Access Compliance Report

Public Rights-of-Way

Intersection ID: 53404	Main Street: MAIN_ST	Cross Street: MORGAN_PARK_DR	Location: SE
ADA ID: 74A2CD5F97AE	Ramp Type: PerpDiag	Initial Pass/Fail: Fail	Overall Compliance: No
Severity Score: 36.25			
Codes/Mitigation Info/Possible Solution		Field Measurements/Component Compliance

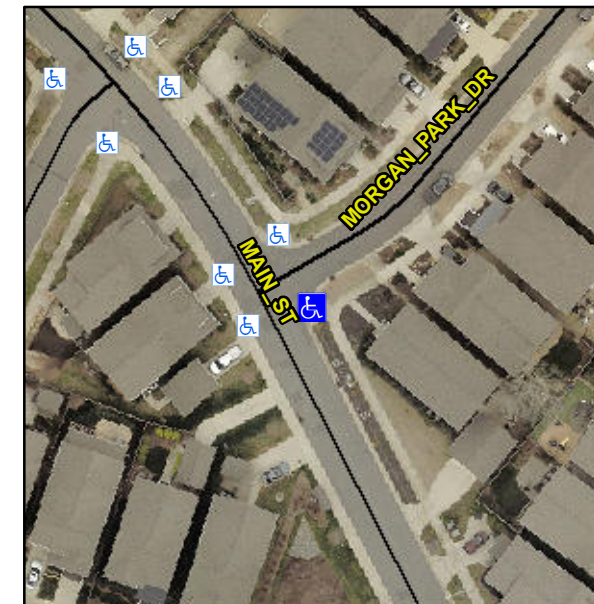
Not Found, R304.5.1, R304.5.3

Compliance	Description	Data	Compliance	Description	Data
N/A	Ramp Length (in)	116.0	Yes	Ramp Slope (%)	5.1
No	Ramp Width (in)	30.5	No	Ramp XSlope (%)	3.0
N/A	Flare Type LT	N/A	N/A	Flare Type RT	N/A
N/A	Flare Slope LT (%)	N/A	N/A	Flare Slope RT (%)	N/A
N/A	Flare Traversable LT?	N/A	N/A	Flare Traversable RT?	N/A
N/A	Landing Length (in)	N/A	N/A	DWS Provided?	N/A
N/A	Landing Width (in)	N/A	N/A	DWS Contrast?	N/A
N/A	Landing Slope (%)	N/A	N/A	DWS Length (in)	N/A
N/A	Landing X Slope (%)	N/A	N/A	DWS Full Width?	N/A
N/A	Landing Curb? (Y/N)	N/A	N/A	DWS Offset (in)	N/A
N/A	Shared Landing?	N/A			
N/A	Gutter Ponding?	N/A	N/A	Gutter Slope (%)	N/A
N/A	Gutter Lip Ht (in)	N/A	N/A	Gutter X Slope (%)	N/A
N/A	Painted X Walk1?	No	N/A	Painted X Walk2?	No
	X Walk 1 Direction	To N		X Walk 2 Direction	To W
N/A	X Walk 1 Width (in)	N/A	N/A	X Walk 2 Width (in)	N/A
	X Walk 1 Slope (%)	3.4		X Walk 2 Slope (%)	2.3
	X Walk 1 X Slope (%)	1.8		X Walk 2 X Slope (%)	0.2

Remove & Replace Curb Ramp With Two New Directional Ramps or Equivalent.
